Design Integrity Report

Detailed State Significant Development Application
Site C, Crows Nest over station development

Author:	CNDC
Date:	28 April 2021
Version:	C
Reference:	SMCSWSCN-SMC-SCN-EM-REP-000016
Review date:	June 2021

North Facade

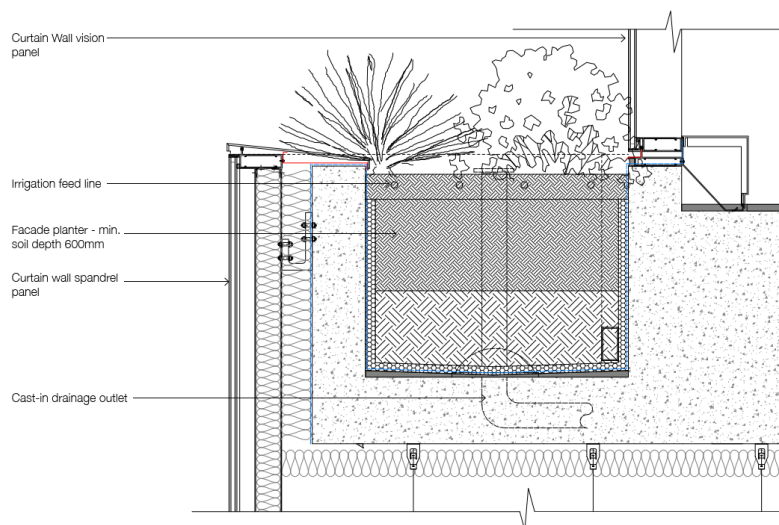
14.09	Site C	Built form	3/12/2019	DRP Presentation 3	Whilst the Panel accepts there may be a future development to the north of Site C, the panel recommends articulation of the north façade be considered. If this is expected to be a blank wall in the interim it needs to be considered.	Design Team	28/01/2020	The Panel accepts that additional detail has been added to the north façade through brick cladding to the top 5m and articulation of brick pilasters.	Closed

North facade while is expected form a parti-wall to future development, a careful consideration has been given to maintain architectural design integrity by allowing brick finish to return on the visible corner. The improvements are the first 5m of the wall from the street is clad in brick to reinforce the solid quality of the brick cladding, the remaining facade is formed in painted precast panels to similarly match the brick appearance, The precast panels mirror the vertical articulation of the south facade where each structural grid is expressed as a pilaster and North Sydney LEP draft plan 2036 indicates the adjoining site can be developed up to 8 levels.
